Subject: Change torque value on Plunger Retainer Nut p/n 70-3016 on crankcase s/a(s) 70-3083, 70-3083M, 70-3073, 70-3073L, 70-3073M, 70-3073ML)

UNITS AFFECTED: 3P20 Titan Series, 5P50 Titan Series

Fig. 1: Drawing sample of Crankcase S/A with the change

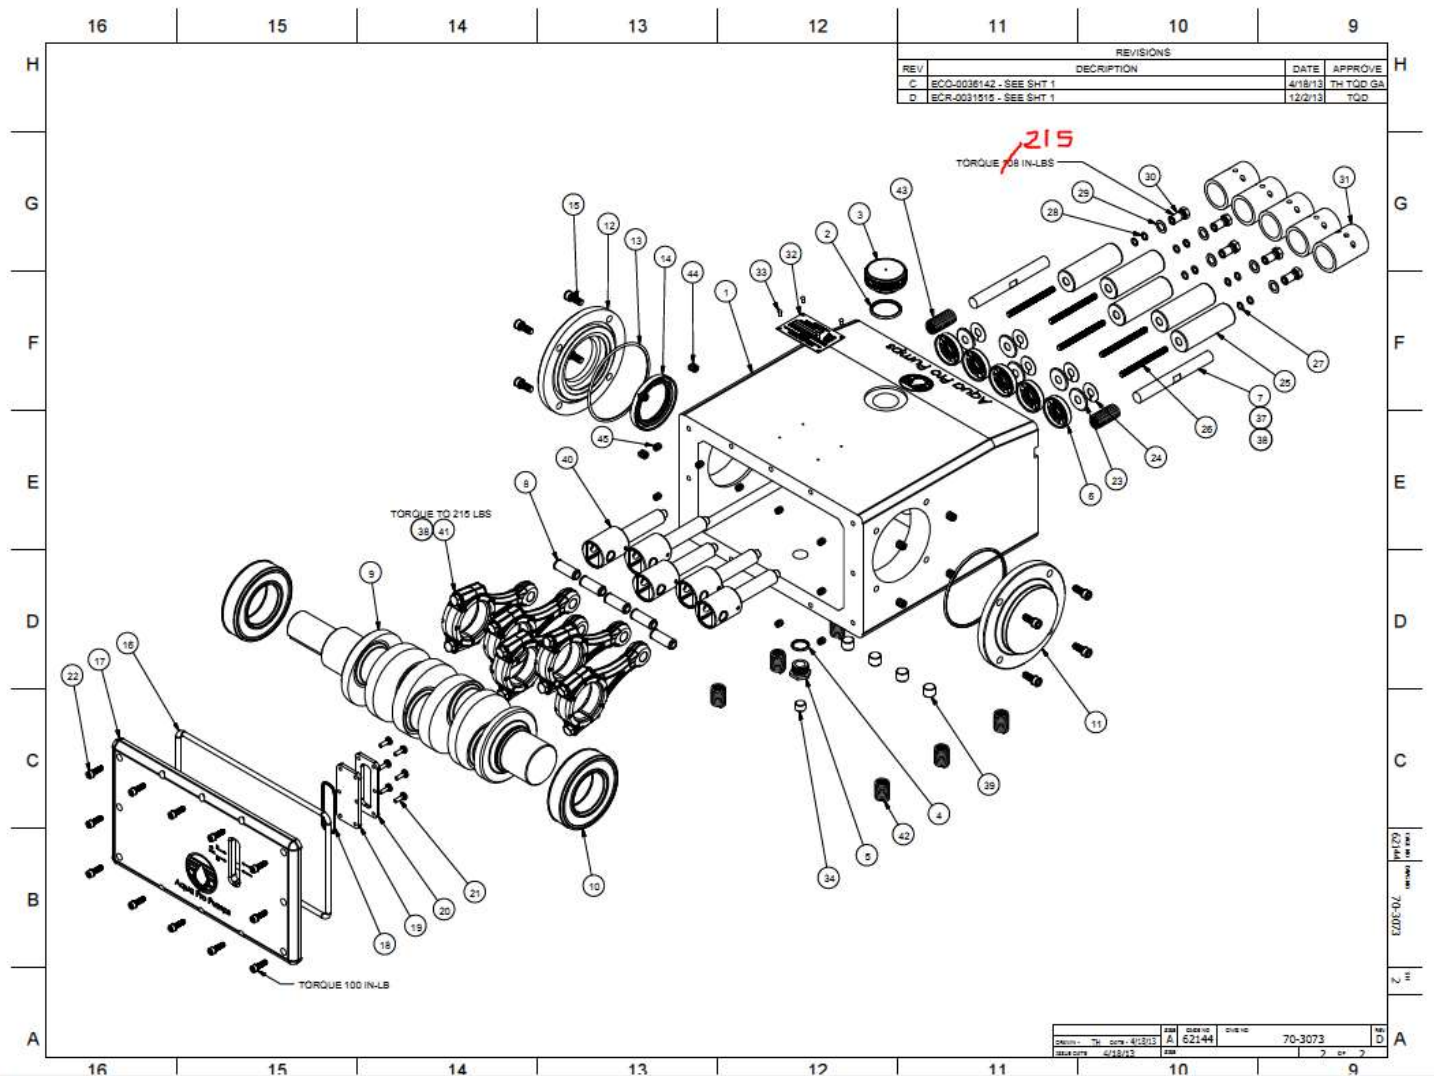
In order to secure the ceramic plunger rods and to document the procedure at the pump production line that has been used, the torque on the plunger retainer nut (p/n 70-3016) has been changed from 104 to 215 in-lbs.
